Office Action Summary

10/568,287

DETAILED ACTION

FIG. 1

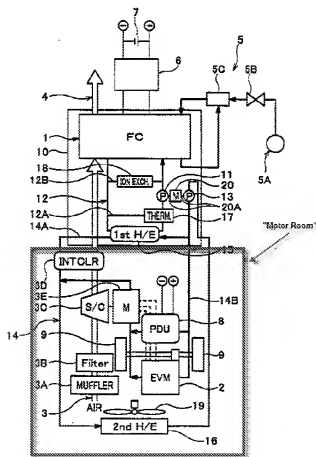
Ogawa further discloses an electric vehicle motor 2 (“drive motor”) outside of the fuel cell box

10. What is considered to be the “motor room” of Ogawa (as it includes the electric vehicle motor 2 and is not located within the limits of the fuel cell box 10) is shown below:

Ogawa teaches a “fuel cell temperature control apparatus” illustrated in Figure 1 which comprises heat exchanger 15, a primary circulation passage (“coolant circuit”) which permits flow of a coolant through the heat exchanger 15 to cool the fuel cell stack (paragraphs 24 and 25); a primary circulating pump 11 (“coolant pump”) disposed in the primary circulation passage

("coolant circuit") so as to circulate the coolant and a bypass flow passage 12A ("bypass circuit") mounted below a passenger floor in the fuel cell box 10 wherein the heat exchanger 15 is connected with the fuel cell 1 through the bypass flow passage 12A ("bypass circuit") which is connected to the primary circulation passage (part of the "coolant circuit") and permits the coolant to bypass the heat exchanger (paragraphs20-28; see Figure 1).

While Ogawa discloses a heat exchanger 15, it is now shown mounted in the motor room; however, the rearrangement of parts, without any new or unexpected results, is an obvious modification of one of ordinary skill in the art. See *In re Japikse*, 181 F.2d 1019, 86 USPQ 70 (CCPA 1950) (see MPEP § 2144.04).

cell box 10. What is considered to be the “motor room” of Ogawa (as it includes the electric vehicle motor 2 and is not located within the limits of the fuel cell box 10) was shown above in Figure 1.
